**Addendum No. 2
January 20, 2023**

Project: Baltic High School Addition
Baltic, South Dakota
Arch Project No. 2957

Architect: Architecture Incorporated

3.41

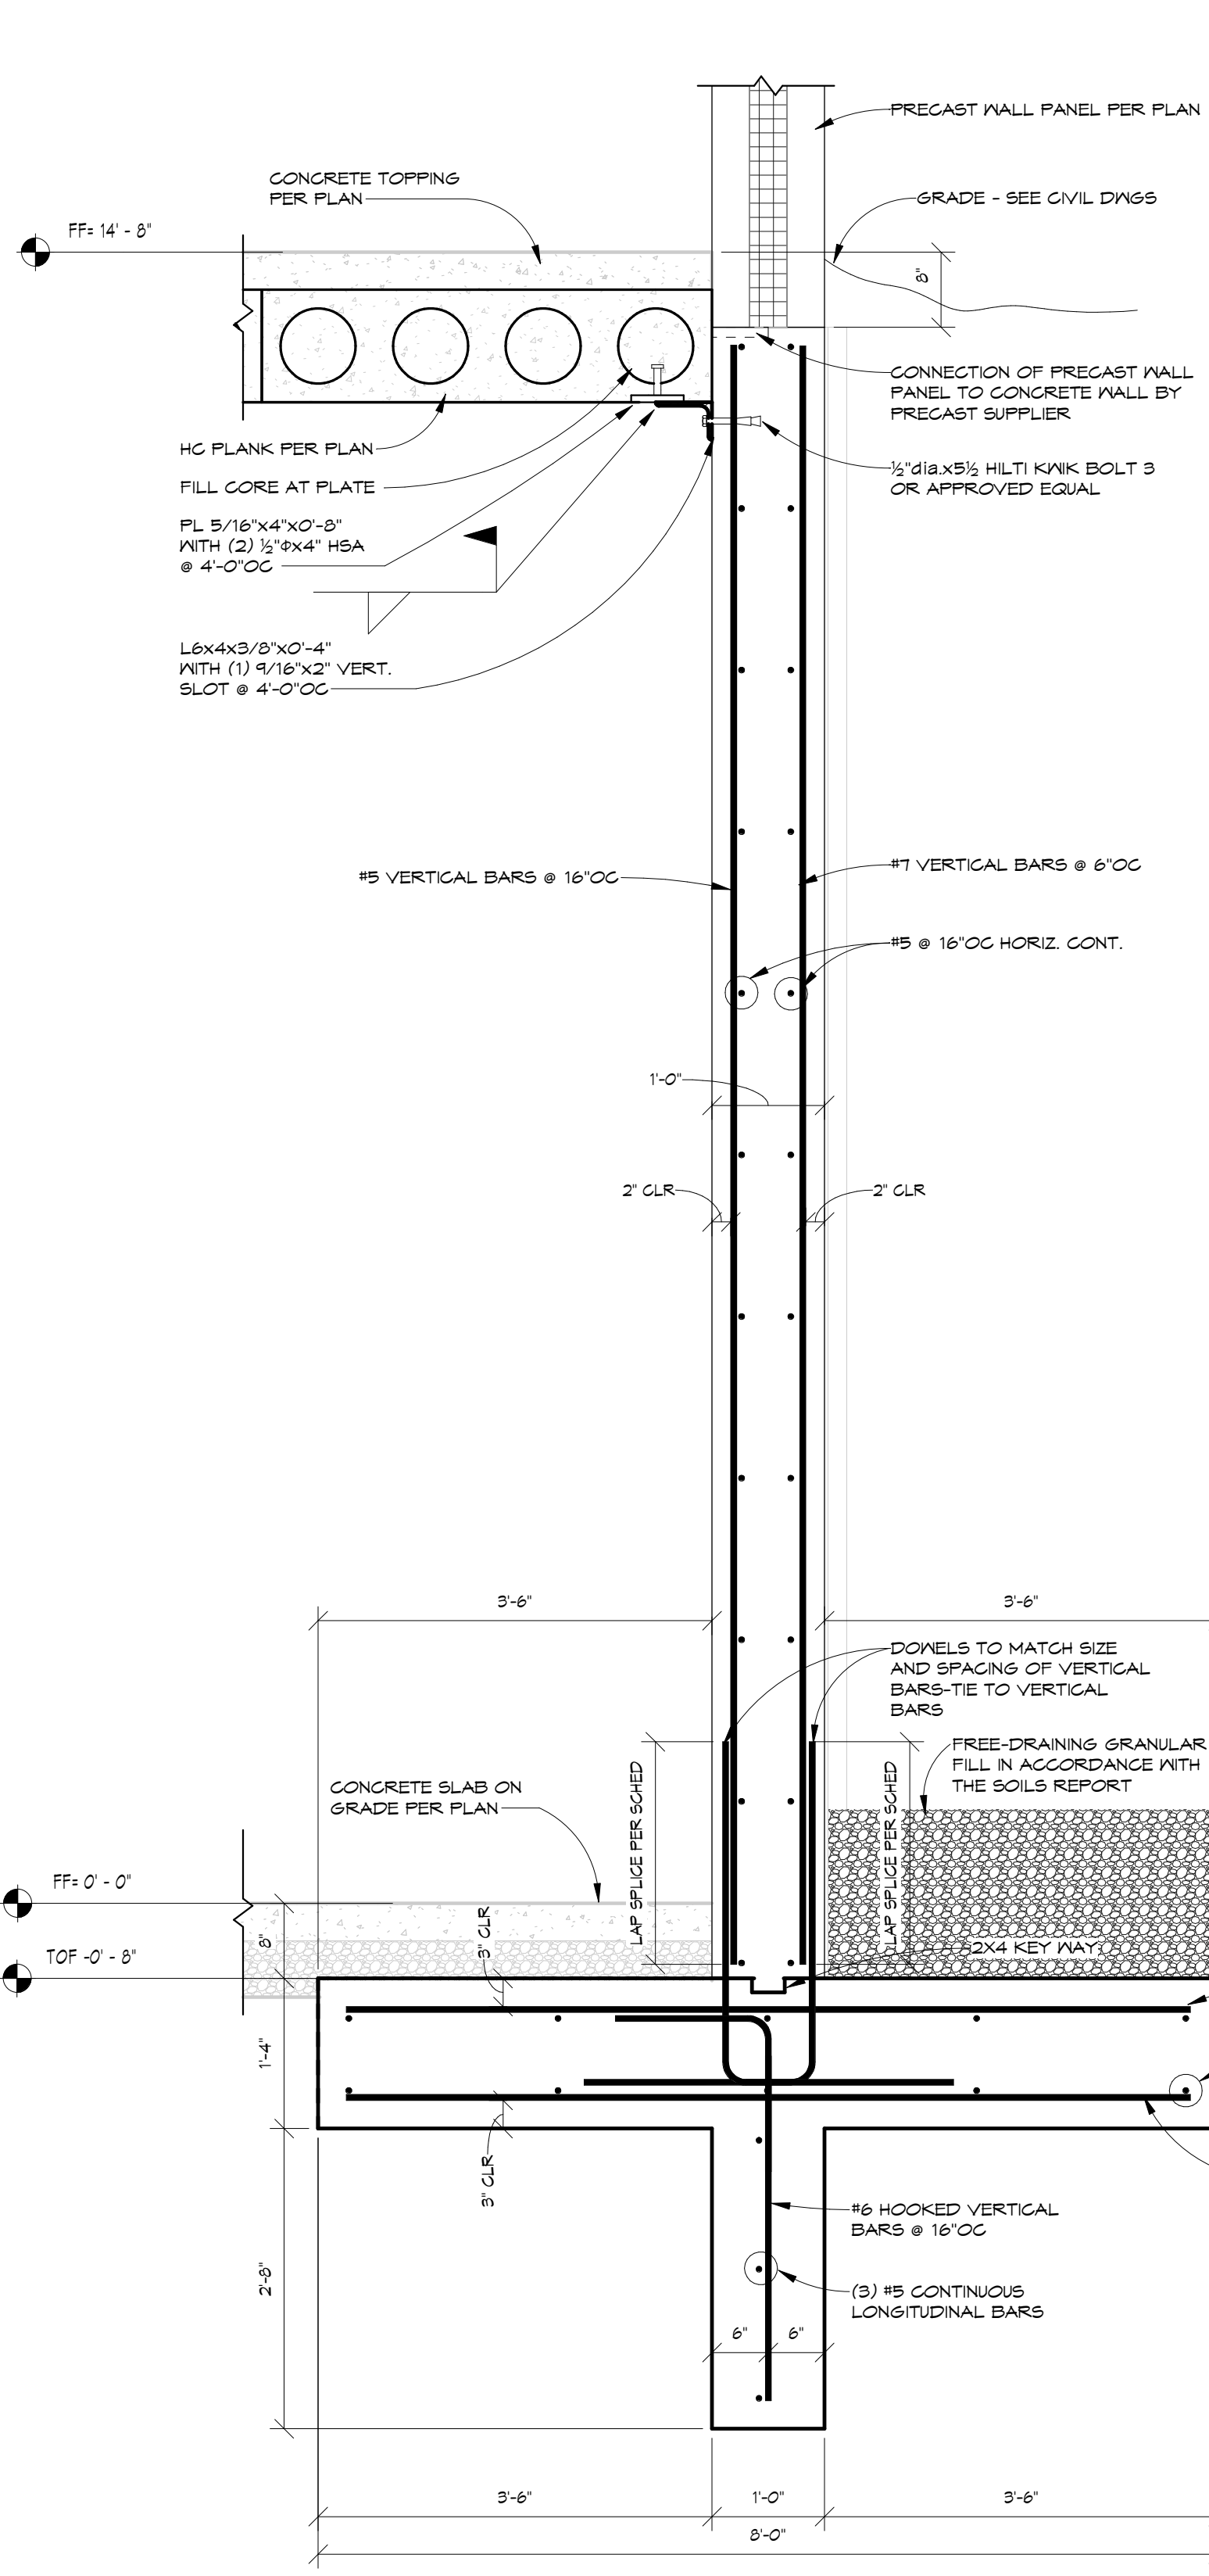
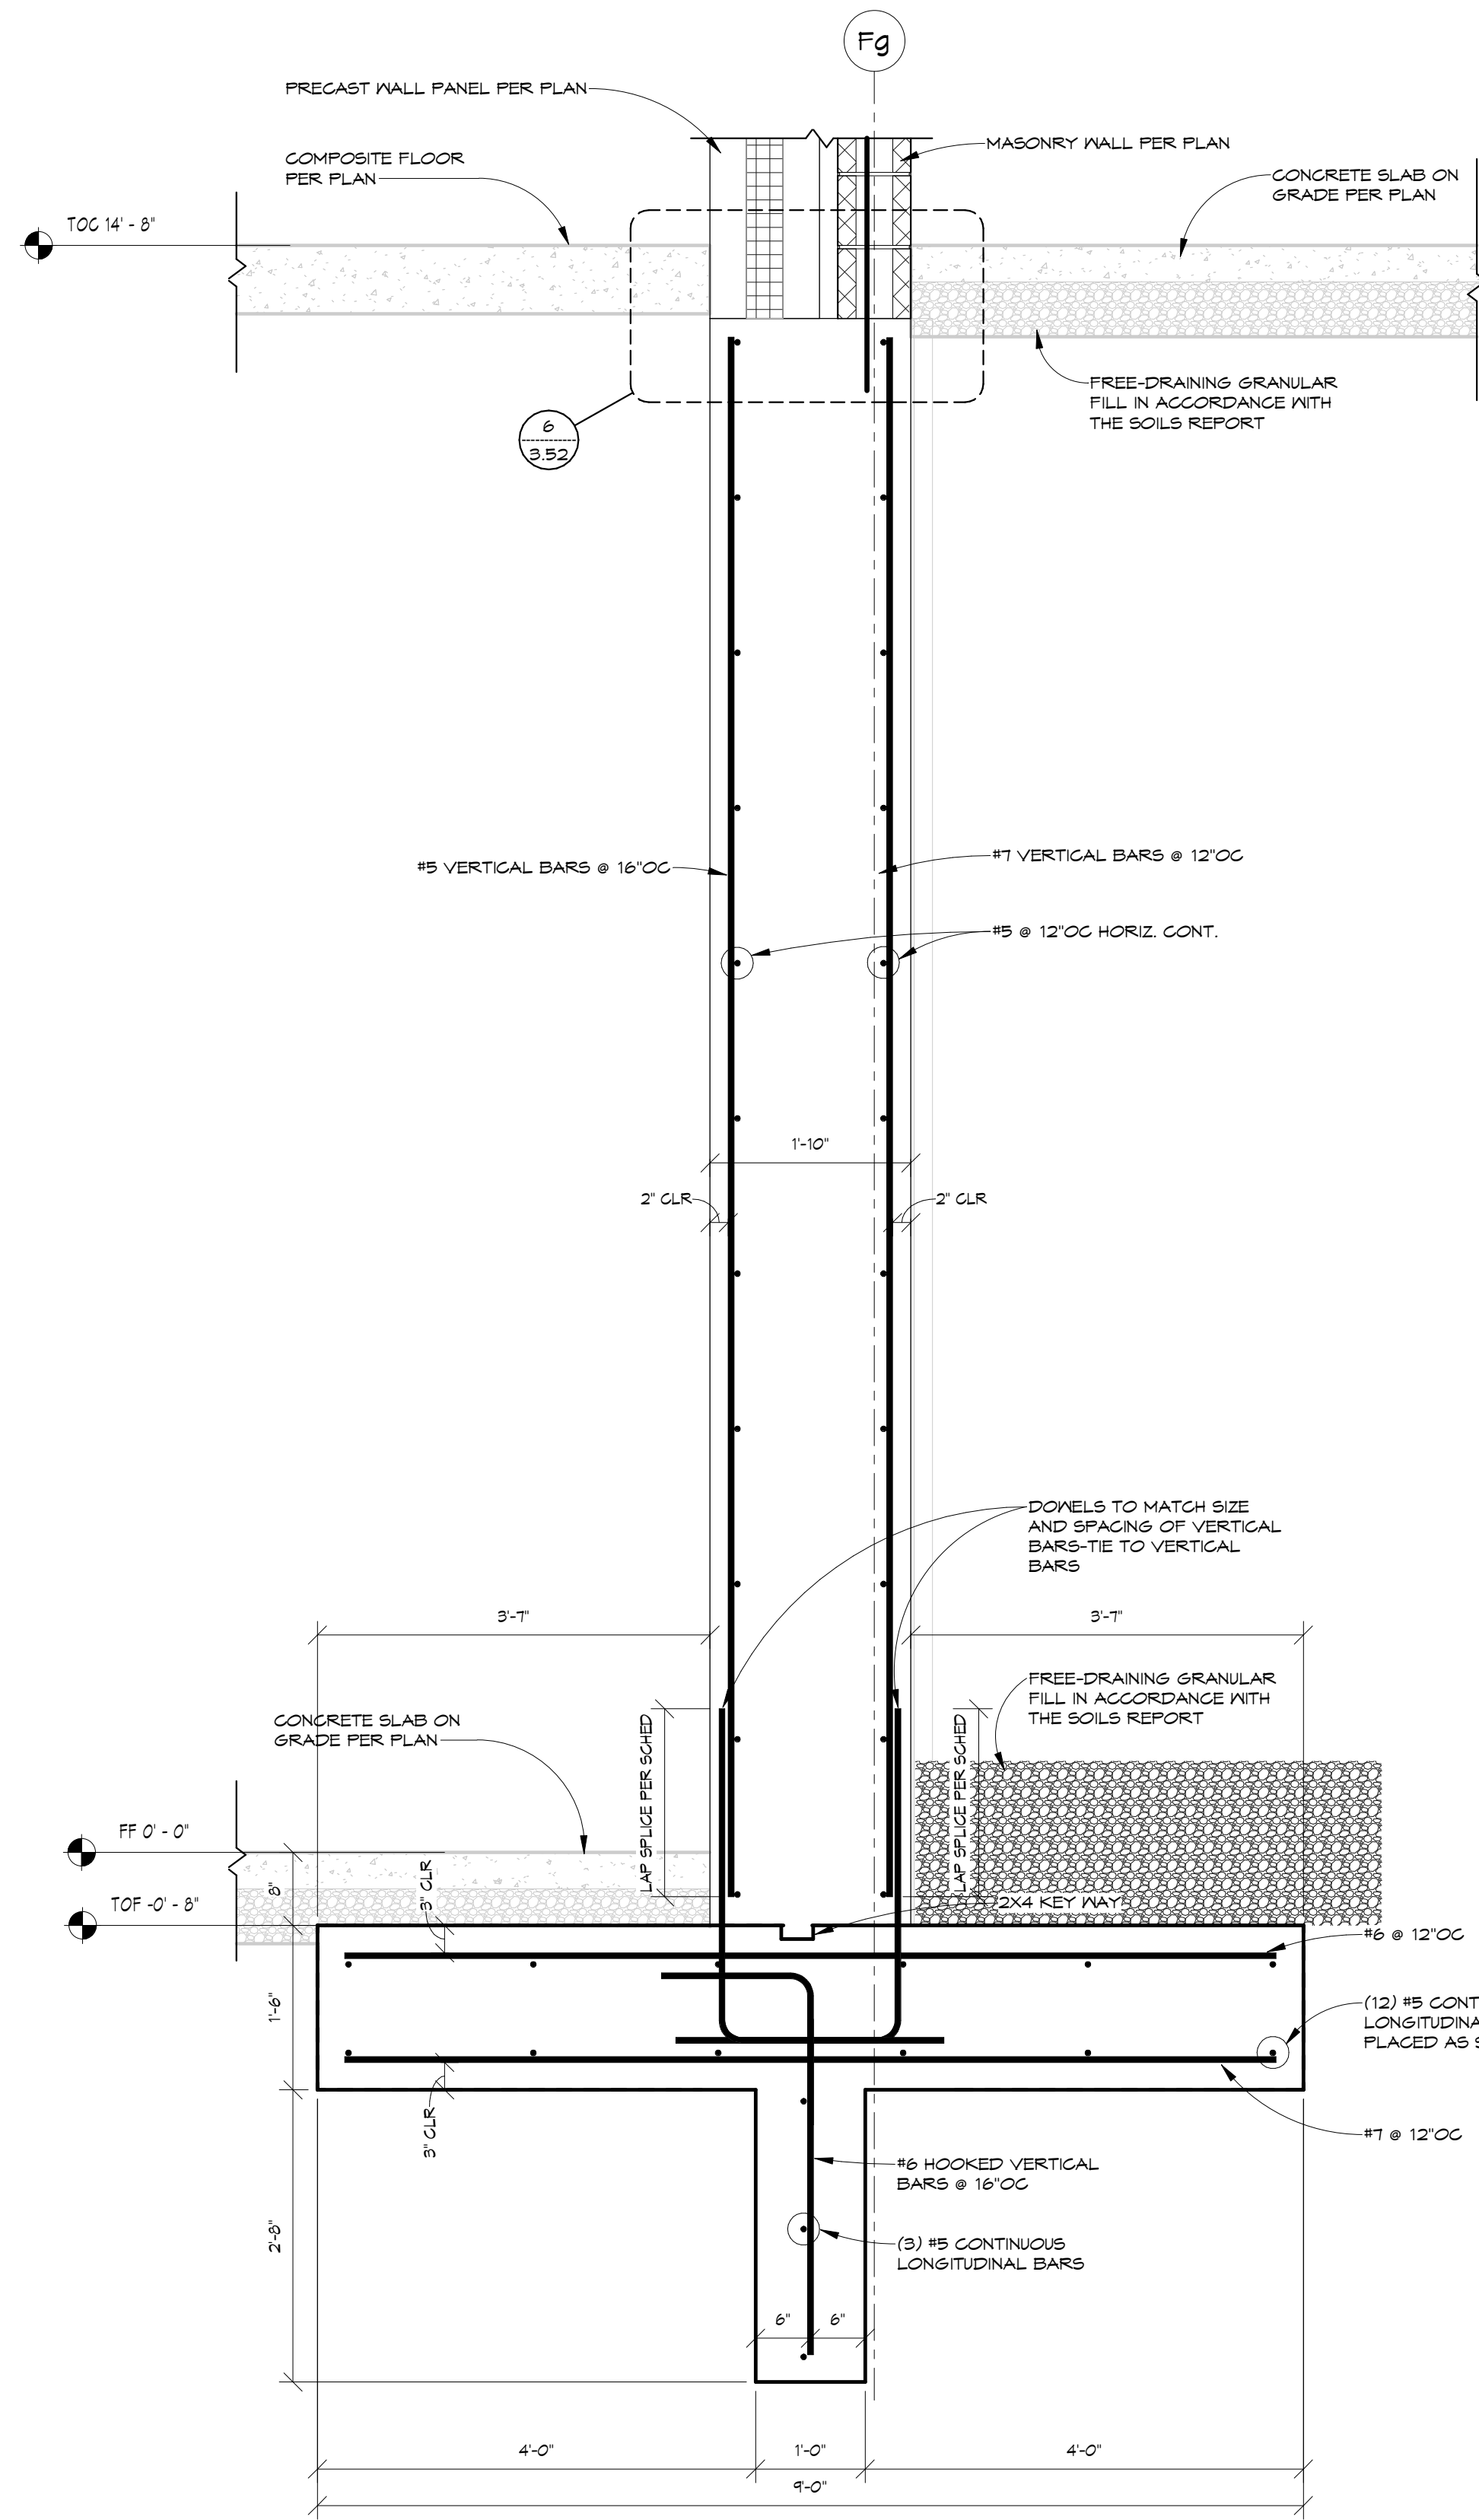
- a) Reference structural Detail 5/3.41: Add footing width dimension of “2’-4” UNO” in lieu of “SEE PLAN”.
- b) Omit structural Detail 6/3.41 in its entirety; not applicable.
- c) Revise structural Detail 7/3.41 as indicated per revised drawing Sheet 3.41.
- d) Reference revised drawing Sheet 3.41, revision dated 1-20-23, attached to the end of this addendum for structural changes listed above.
